WASTEWATER DESIGN SUBMISSION SAMPLE DRAWING.

**WATERMAIN
DESIGN SUBMISSION
SAMPLE DRAWING.**

WASTEWATER DESIGN SUBMISSION SAMPLE DRAWING.

1:500 SITE LAYOUT SHOWING DIVERTED WASTEWATER SEWER

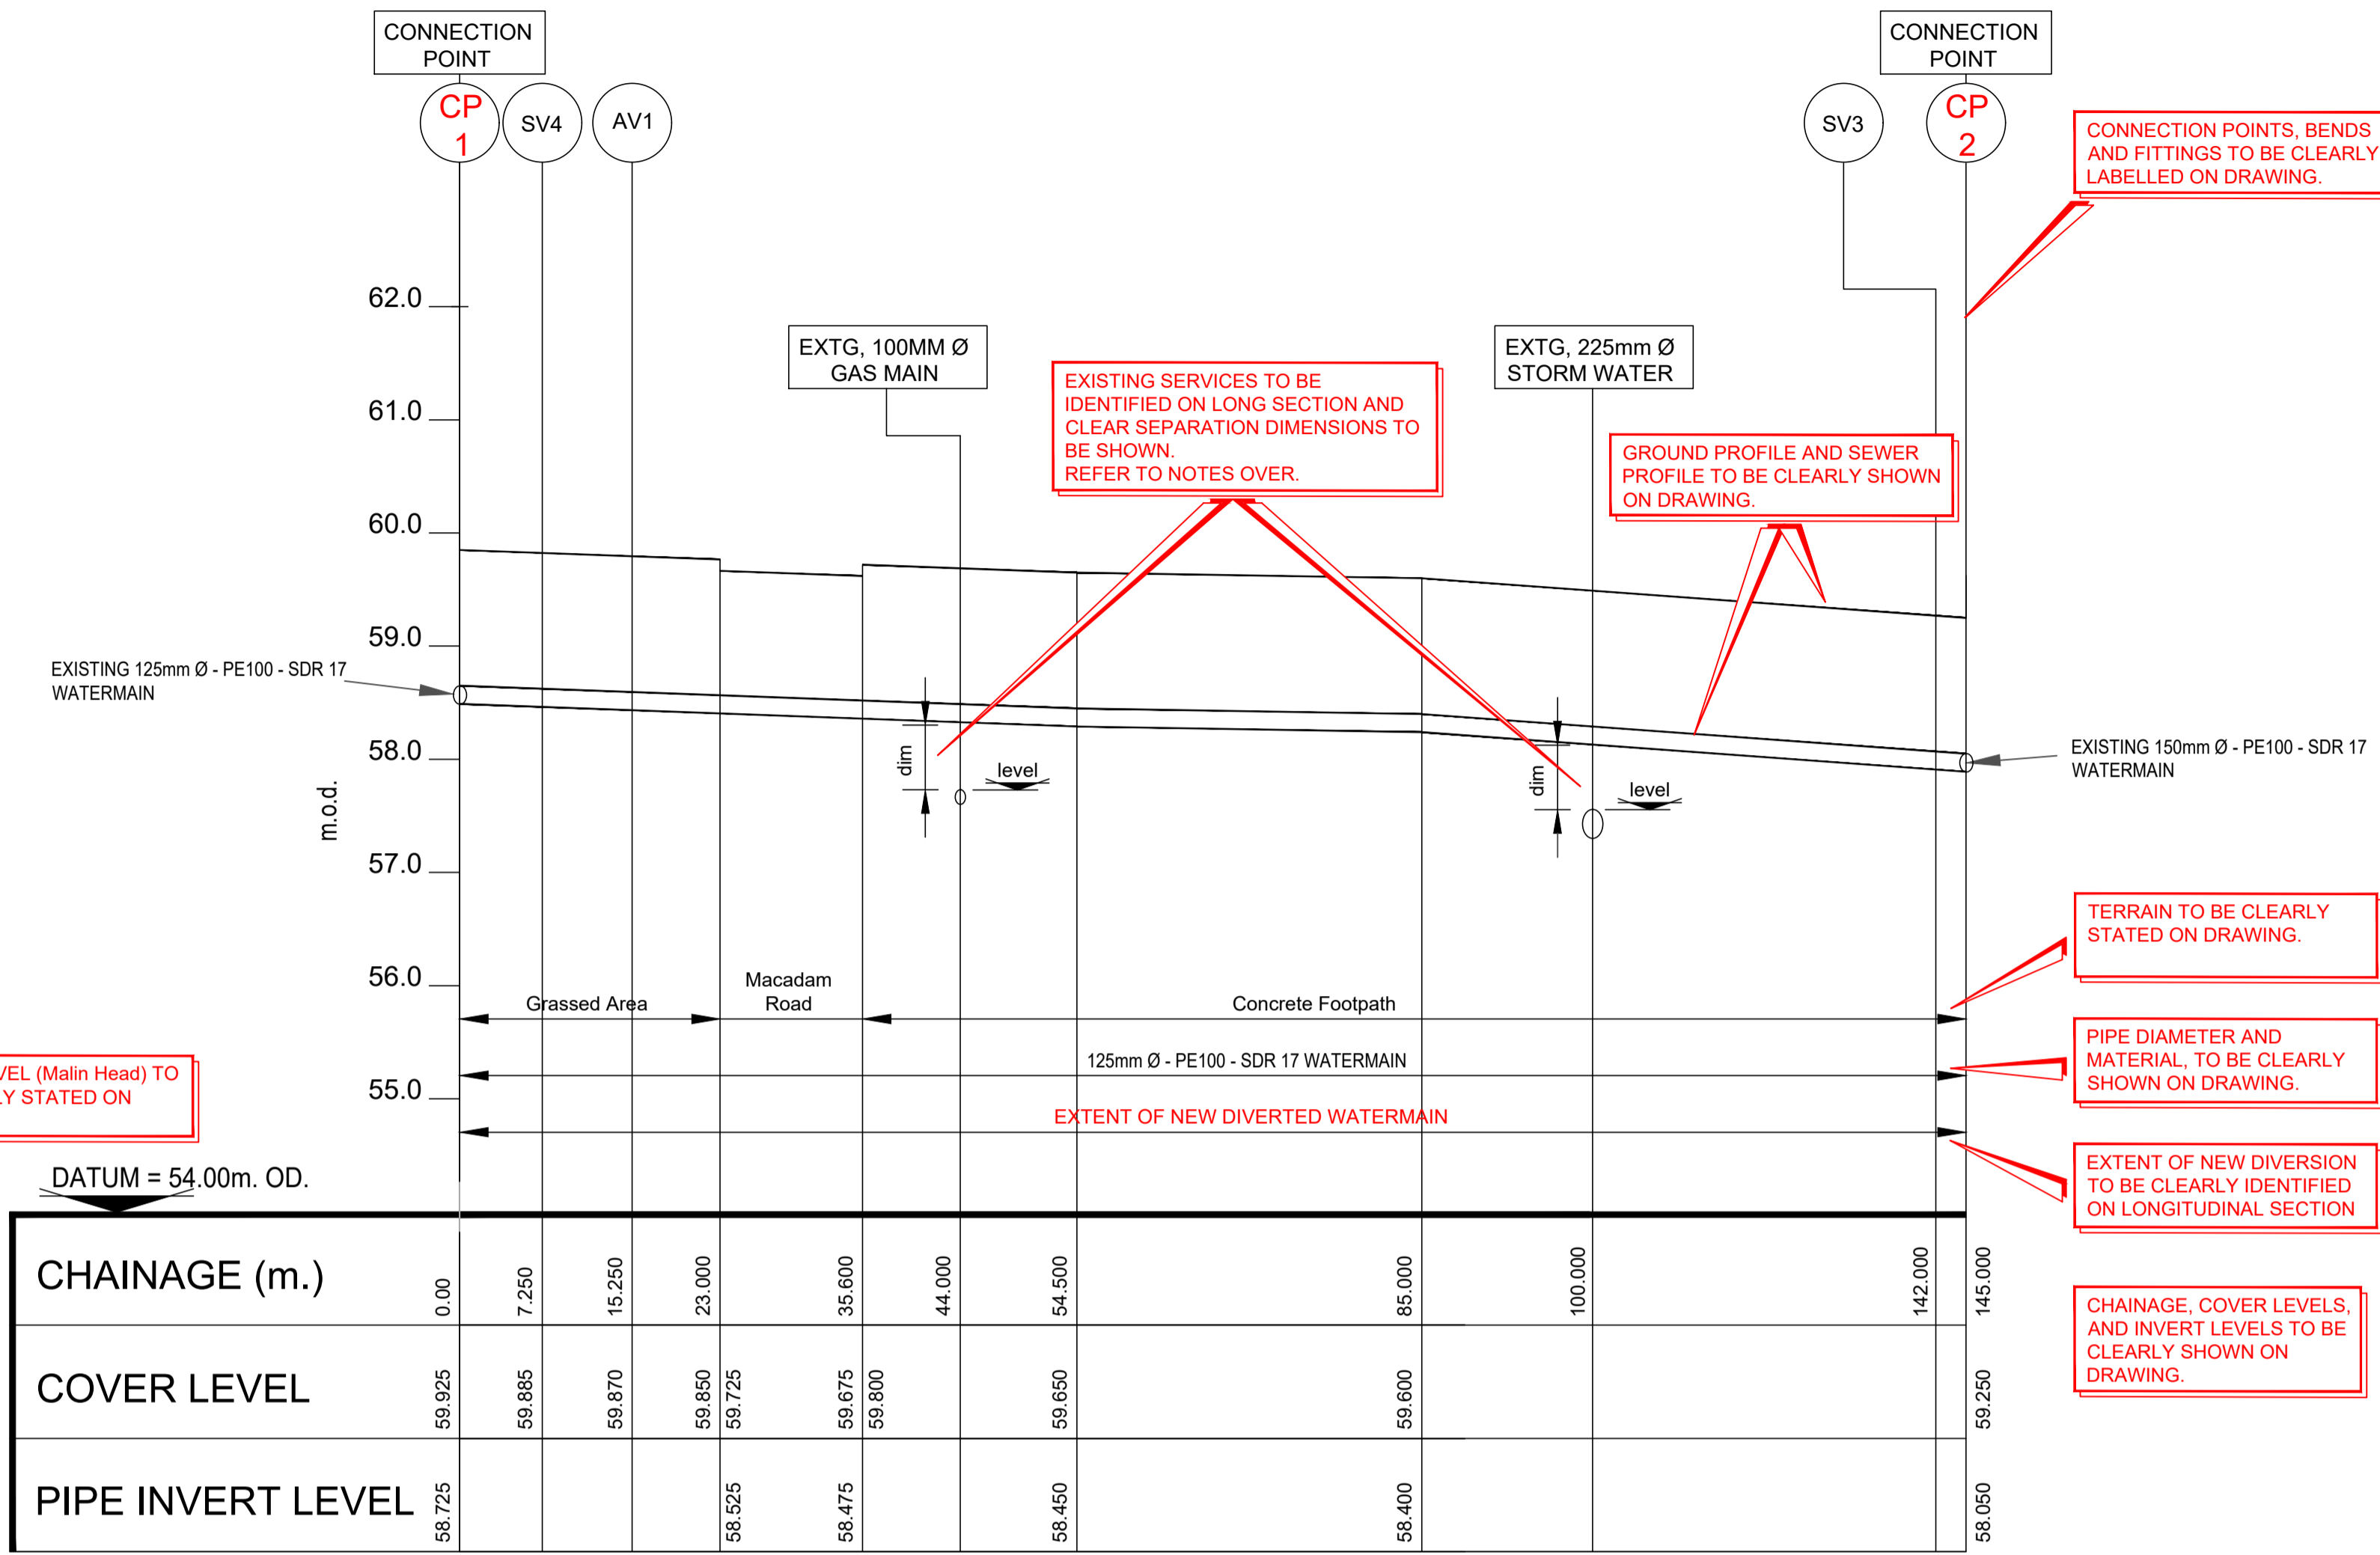
NORTH POINT TO BE PROVIDED ON DRAWING

NOTE:-
SEWER PIPE MATERIAL TO BE INCLUDED IN ANNOTATION
e.g. 150mmØ WW uPVC SN8 SEWER.
SEWERS TO COMPLY WITH PIPE MATERIAL TYPES OUTLINED IN THE CODE OF PRACTICE FOR WASTEWATER INFRASTRUCTURE.
CONCRETE: TO IS EN 1916 (2002), BS 5911, PART 1 (2002-2010) AND IS 6 (2004)
THERMOPLASTIC STRUCTURED WALL PIPES: TO IS EN 13476 (2007/2009) (SN8 STIFFNESS CLASS).
UNPLASTICISED PVC: TO IS EN 1401 (2009-2012) (SN8 STIFFNESS CLASS).
POLYETHYLENE: TO IS EN 12201 AND IS EN 12201 PART 3.
DUCTILE IRON: TO IS EN 598.

TABULATED SCHEDULE SHOWING COVER LEVELS, INVERT LEVELS AND COORDINATES TO BE PROVIDED ON DRAWING (Excel Format Preferably)

DRAWING TO BE REVISED ACCORDINGLY			
REV. A	MAR 2021	DESIGN SUBMISSION	BY CHKD/APP

Development
DEVELOPMENT TITLE TO BE CLEARLY STATED.

Developer / Consultant
NAME AND ADDRESS OF DEVELOPER AND CONSULTANT TO BE CLEARLY SHOWN.

Title
WASTEWATER AS-BUILT SITE LAYOUT.
DRAWING TITLE TO BE CLEARLY STATED.

SAMPLE WATERMAIN LONGITUDINAL SECTION

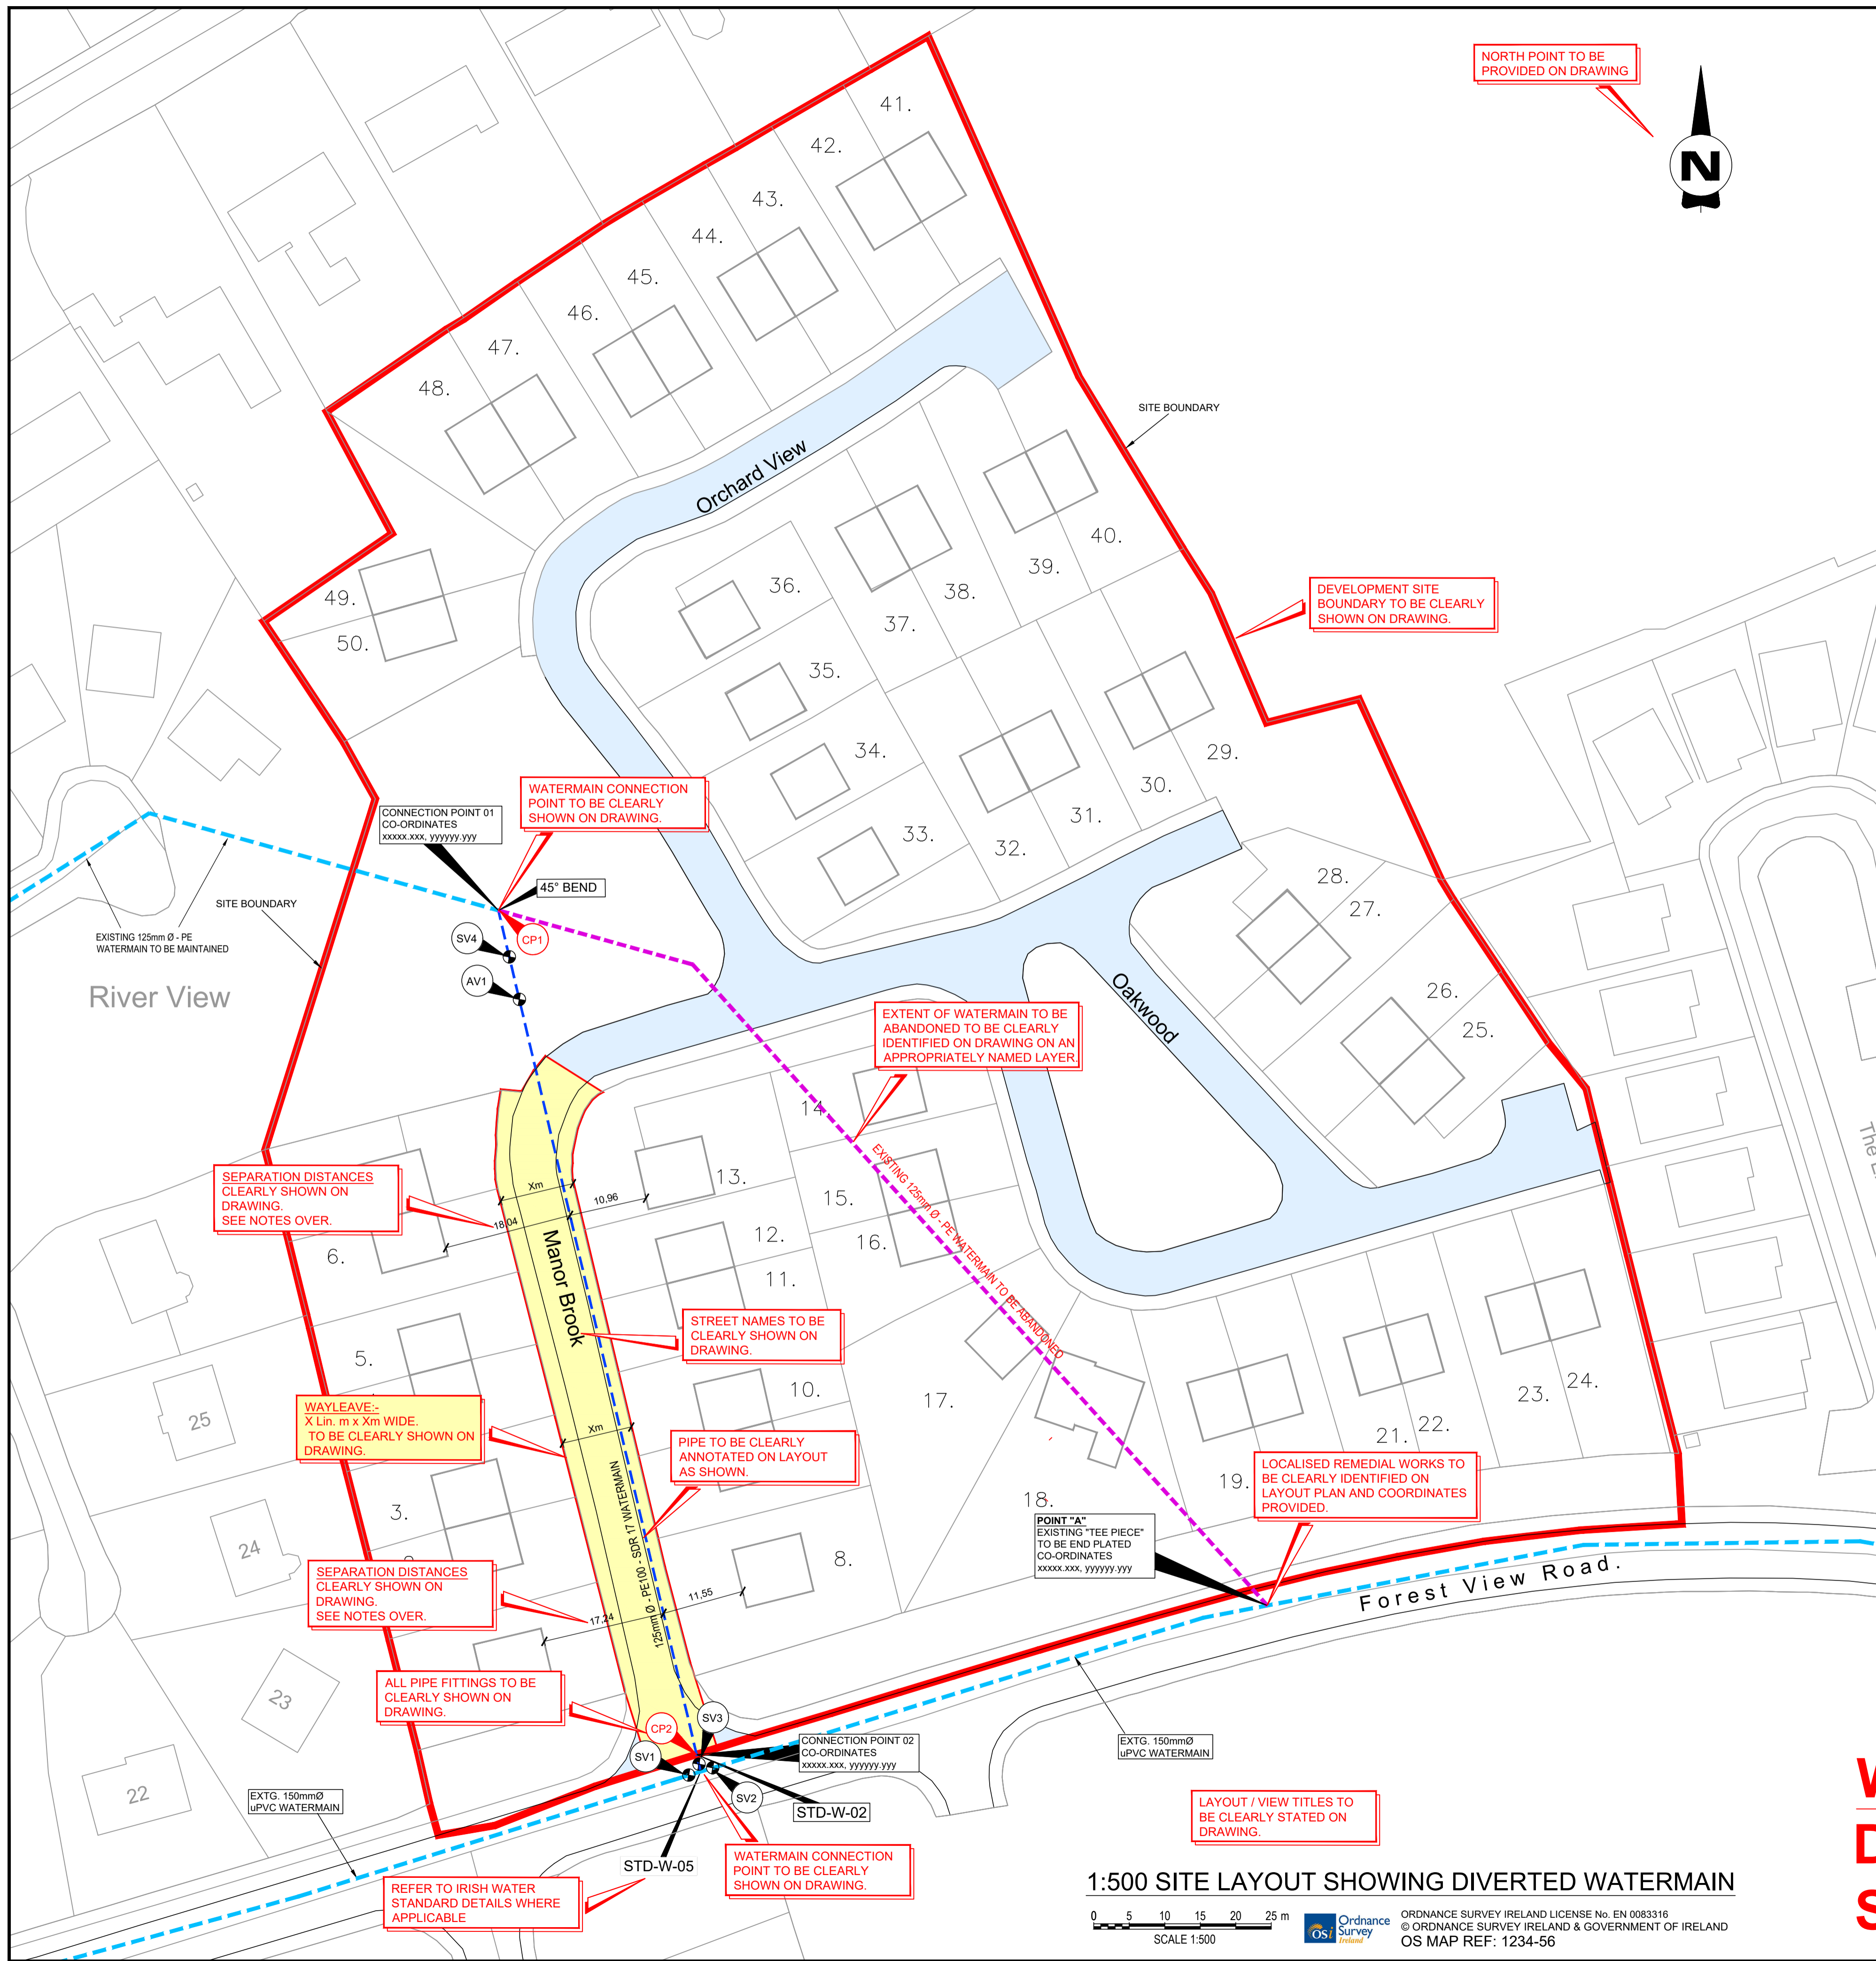
LAYOUT / VIEW TITLES TO BE CLEARLY STATED ON DRAWING.

DATUM LEVEL (Malin Head) TO BE CLEARLY STATED ON DRAWING.

EXISTING SERVICES TO BE IDENTIFIED ON LONG SECTION AND CLEAR SEPARATION DIMENSIONS TO BE SHOWN. REFER TO NOTES OVER.

GROUND PROFILE AND SEWER PROFILE TO BE CLEARLY SHOWN ON DRAWING.

CONNECTION POINTS, BENDS AND FITTINGS TO BE CLEARLY LABELLED ON DRAWING.

TERRAIN TO BE CLEARLY STATED ON DRAWING.

PIPE DIAMETER AND MATERIAL TO BE CLEARLY SHOWN ON DRAWING.

EXTENT OF NEW DIVERSION TO BE CLEARLY IDENTIFIED ON LONGITUDINAL SECTION

CHAINAGE, COVER LEVELS, AND INVERT LEVELS TO BE CLEARLY SHOWN ON DRAWING.

DRAWING TO BE REVISED ACCORDINGLY			
A	MAR 2021	DESIGN SUBMISSION	RH RH MF
REV.	DATE	DESCRIPTION	BY CHKD APPR

1:500 SITE LAYOUT SHOWING DIVERTED WATERMAIN

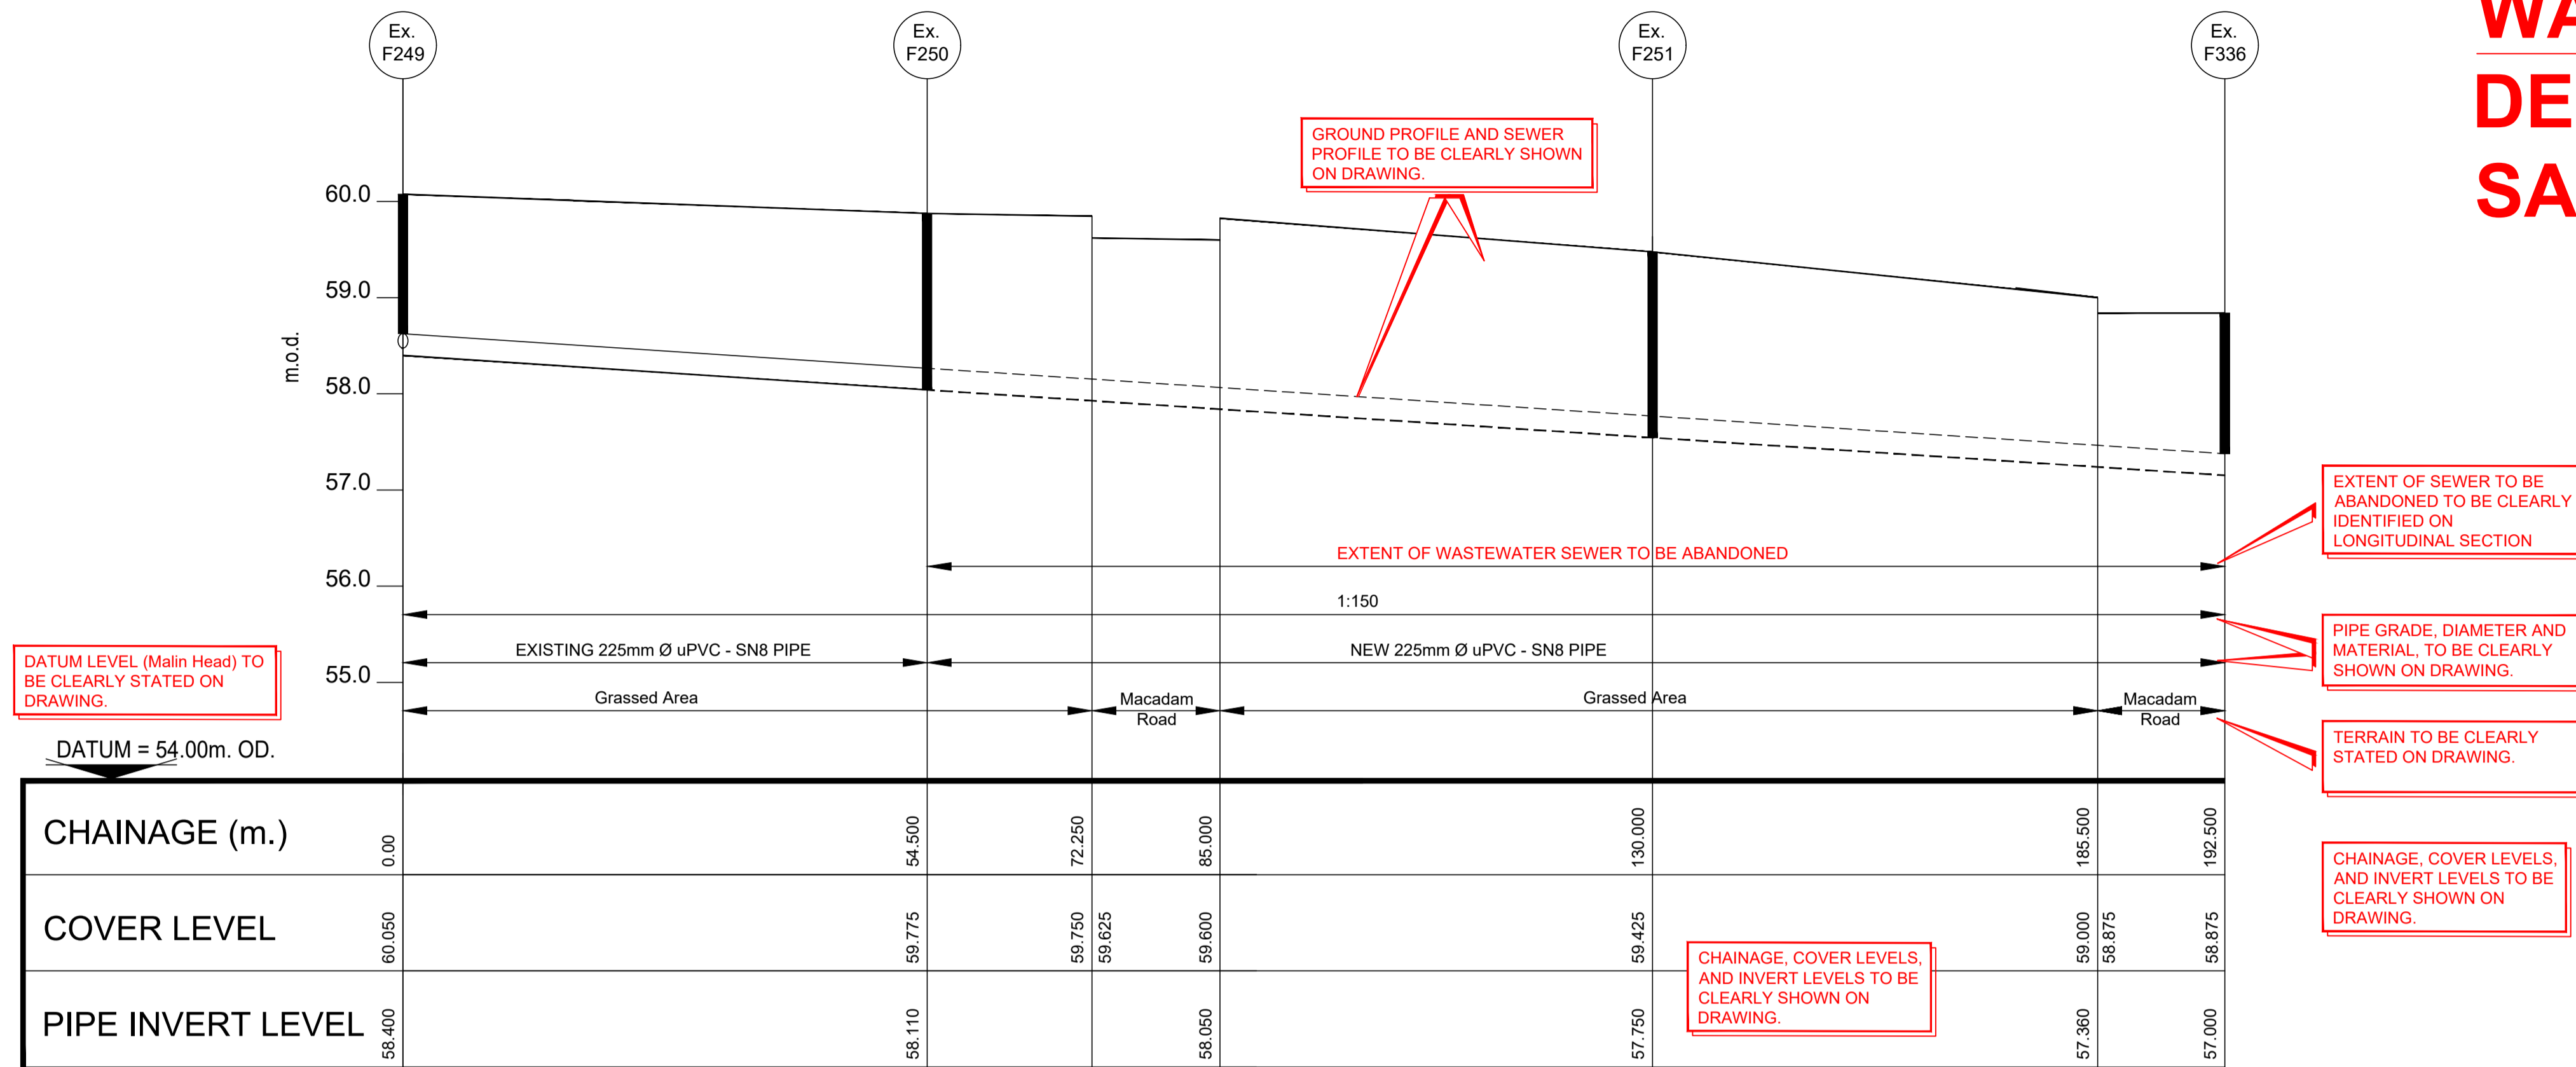
NORTH POINT TO BE PROVIDED ON DRAWING

DRAWING TO BE REVISED ACCORDINGLY					
A	MAR 2021	DESIGN SUBMISSION	RH	RH	MF
REV.	DATE	DESCRIPTION	BY	CHKD	APPR

DEVELOPMENT TITLE TO BE CLEARLY STATED.

NAME AND ADDRESS OF DEVELOPER AND CONSULTANT TO BE CLEARLY SHOWN.

DRAWING TITLE TO BE CLEARLY STATED.

NOTE:- AT DESIGN SUBMISSION STAGE, DRAWINGS AND COORDINATES ORIENTATED TO ITM GRID REFERENCE ARE ACCEPTABLE.
